Enclosure 4 to E-55865

SAR Changed Pages

Figure 7-61
Cask Handling Building Structural Steel Framing Arrangement, Plan View at Roof Top Chord
(Bottom Chord Similar)

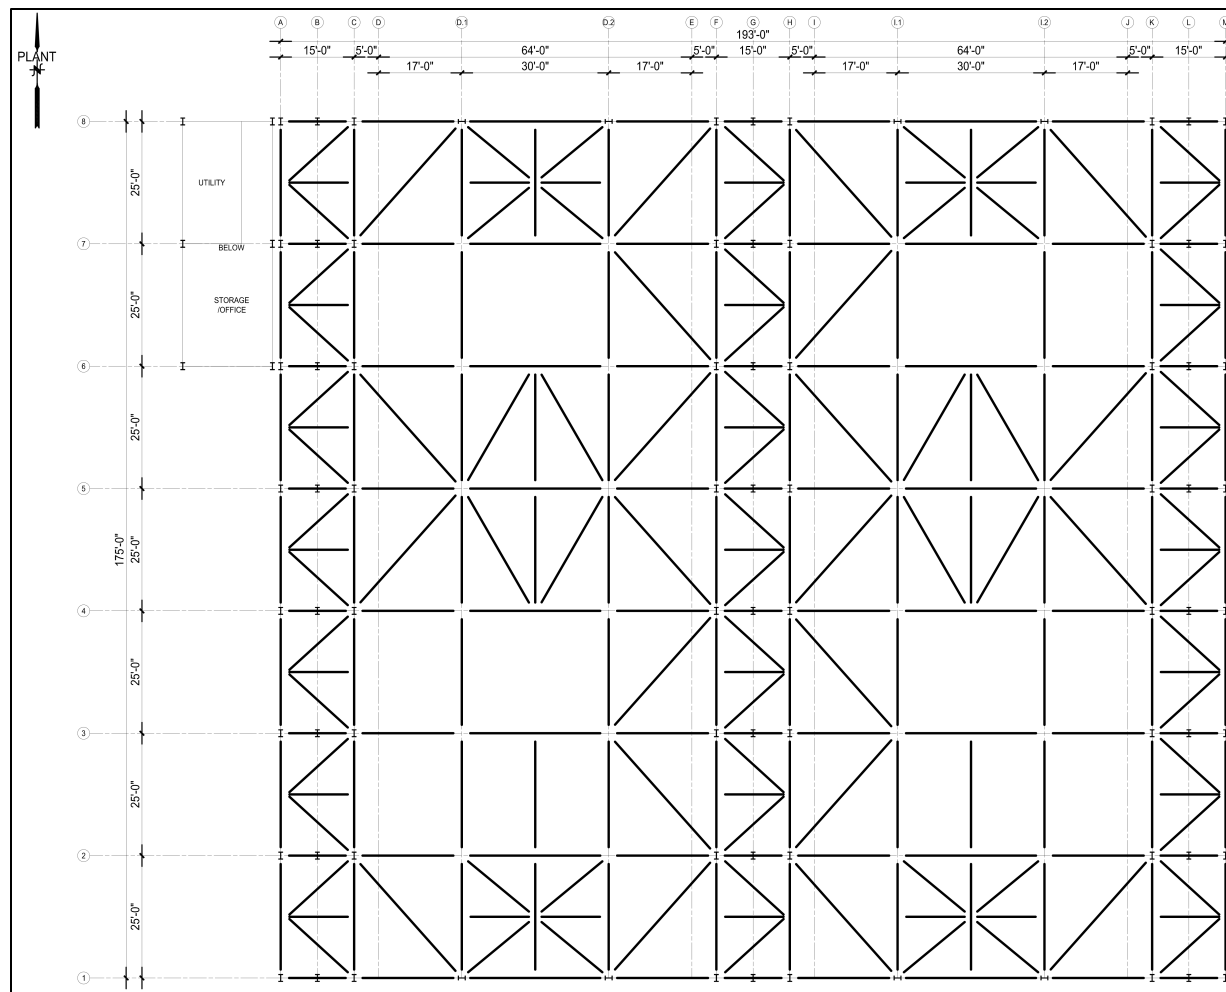
As shown in Figures 7-54 through 7-61, the CHB steel building is a braced frame structure with column centerline grid plan dimensions of 175'-0" (north-south) by 193'-0" (east-west) and an eave height 72'-0" above the top of the concrete foundation (Elevation 100'-0" in the figures). The roof is gabled with 1/4-inch per foot slope on each side and peak ridge elevation of 174'-0 1/8". The north-south plan dimension of the building comprises seven equal bays of 25'-0" spacing, with vertically braced interior bays similar to those shown in Figure 7-56 on column lines A, C, F, H, K, and M. The east-west plan dimension comprises two crane bays with 64'-0" spacing between independent crane support columns that are laterally supported by three separate vertically braced frames at column lines A-C, F-H, and K-M (see Figures 7-55 and 7-56). All seven east-west column lines support a primary lateral roof truss system that is tied together with a secondary north-south bridging roof truss system and horizontal roof bracing at the top and bottom truss chord levels. The primary roof trusses vary in depth from 7'-6" at the eave to 9'-6 1/8" at the ridge. The vertical bracing and primary roof truss arrangement is shown in Figure 7-56, with the secondary bridging roof trusses and horizontal roof truss chord bracing shown in Figures 7-60 and 7-61, respectively.

Figure 7-55 through Figure 7-60 illustrate typical member size groups utilized for CHB primary framing. Member size classes utilized for each primary framing member category are also summarized in Table 7-41. Further discussion of the CHB structural steel analysis and design is given in Sections 7.5.3.3 and 7.5.3.4.

To evaluate the performance of the CHB steel framing shown in Figures 7-54 through 7-61, the building is modeled in a detailed three-dimensional structural analysis model and subjected to all of the applicable design load cases and load combinations defined above in Sections 7.5.3.2.1 and 7.5.3.2.2. The assumption of linear elastic response for static, seismic, and tornado wind loads permits separate analysis of each loading condition and superposition of applicable load case member forces and moments to determine total load combination demands for evaluation vs. code defined member capacities.

Figure 7-56

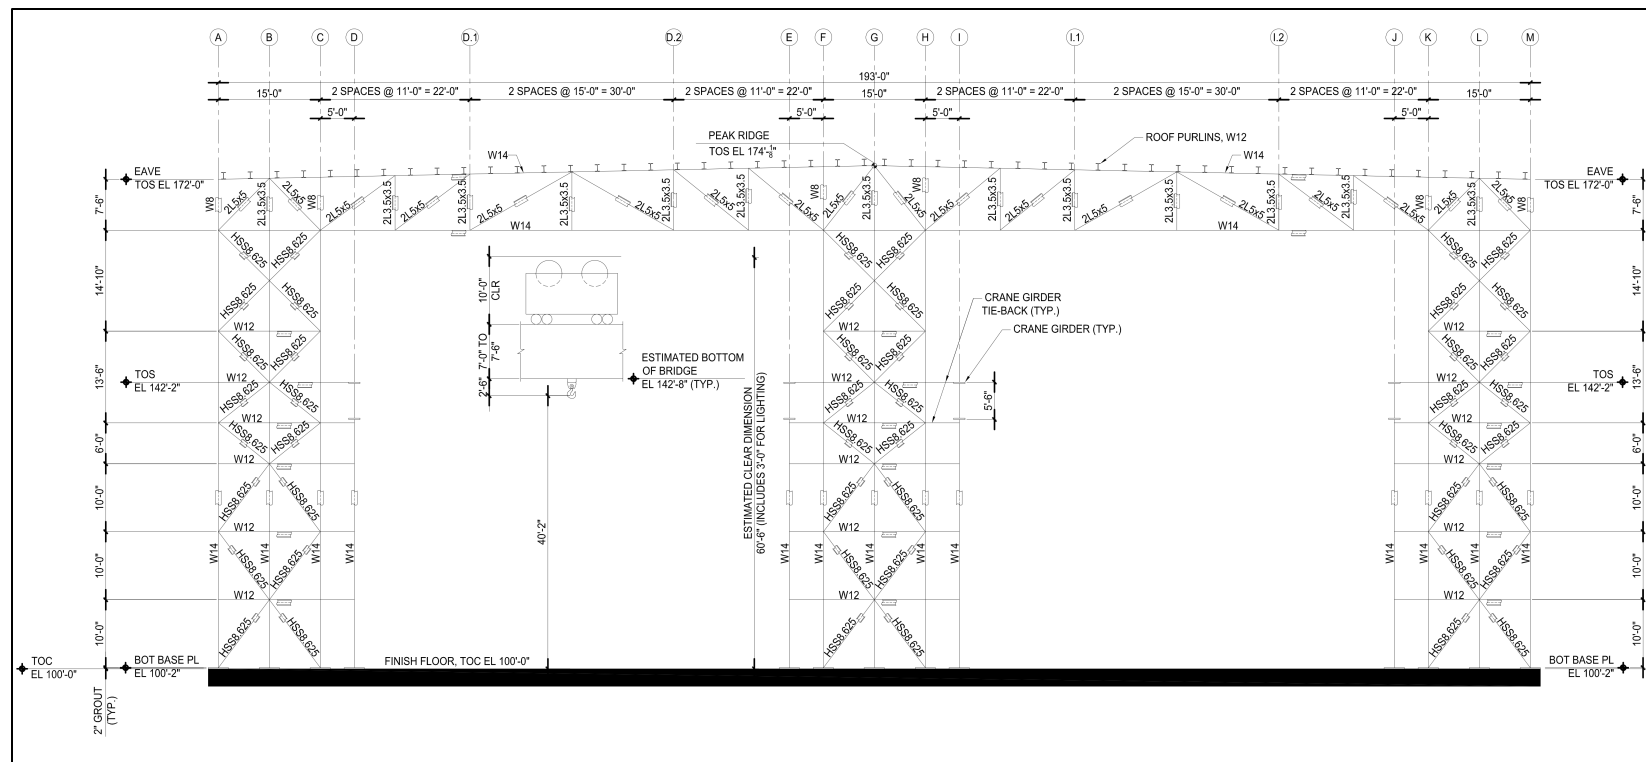
The framing arrangement shown in Figure 7-56 and utilized on all seven east-west column lines provides lateral system redundancy, distributed lateral stiffness with limited torsional irregularity, and sufficient lateral stiffness to meet drift limitations for bridge crane supporting structures. These design objectives are further achieved via the arrangement of the roof bracing system (i.e., diaphragm); see Figures 7-54, 7-60, and 7-61. As shown, the primary east-west roof trusses are laterally supported by the secondary bridging trusses framed along the full north-south length of the building at the two wind column lines in each crane bay (Column lines D.1, D.2, I.1, and I.2; a typical section at line I.2 is shown in Figure 7-60). Horizontal diagonal roof bracing in the planes of the top and bottom chords is then provided between the primary and secondary trusses to create a continuous roof diaphragm that assures system redundancy by distributing lateral loads among the north-south and east-west braced column lines. The continuous roof diaphragm also limits relative drift of individual vertical frames subjected to localized lateral forces imparted by the cranes.

Figure 7-62
Cask Handling Building 3D STAAD.Pro Finite Element Model

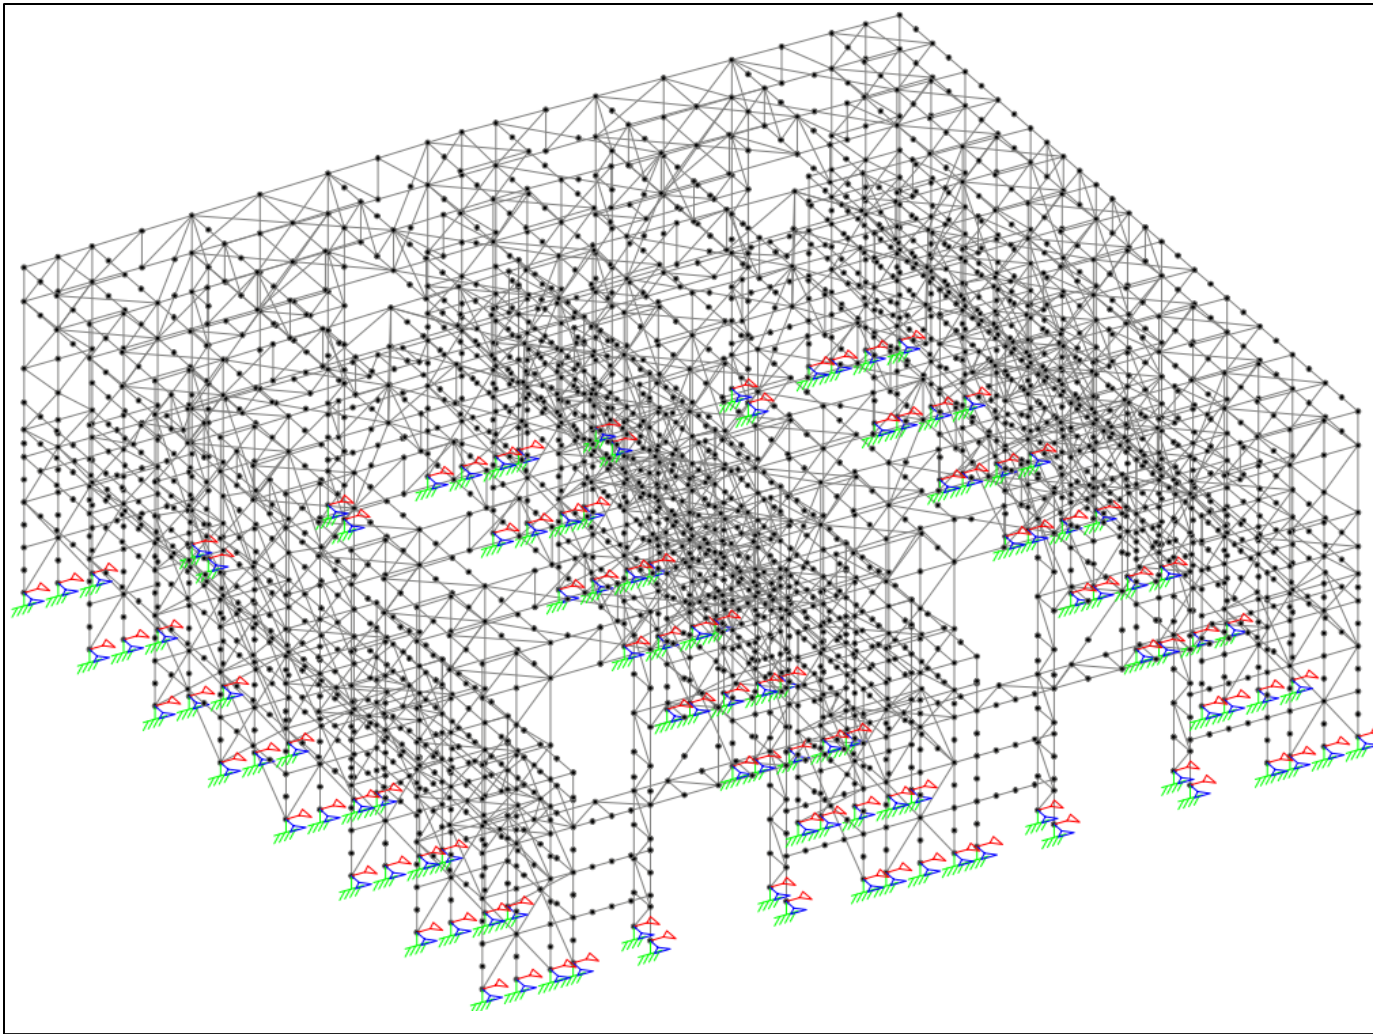
Figure 7-62 shows an isometric view of the three-dimensional finite element analysis model generated in program STAAD.Pro (STAAD). The STAAD version utilized is the CONNECT Edition, Version 22.01.00.38, which is verified and validated under an ASME NQA-1 compliant quality program.

The model includes approximately 3100 nodes and 5800 beam elements, with the intent of sufficient refinement to provide an accurate assessment of structure response to static and dynamic loading. The STAAD beam elements are formulated with six degrees of freedom per node (three translations and three rotations) and with shear deformation effects included in the member stiffness matrix. STAAD utilizes a diagonal, lumped mass matrix approach, with mass terms at all active degrees of freedom. Since dynamic analysis is performed to evaluate the CHB for seismic and tornado missile loading, members with significant transverse loading between points of support (e.g., beams and girders) are subdivided into multiple beam elements to capture dynamic flexural responses while utilizing the STAAD lumped mass formulation. At a minimum, three intermediate nodes (four elements) are used for all beams and girders.
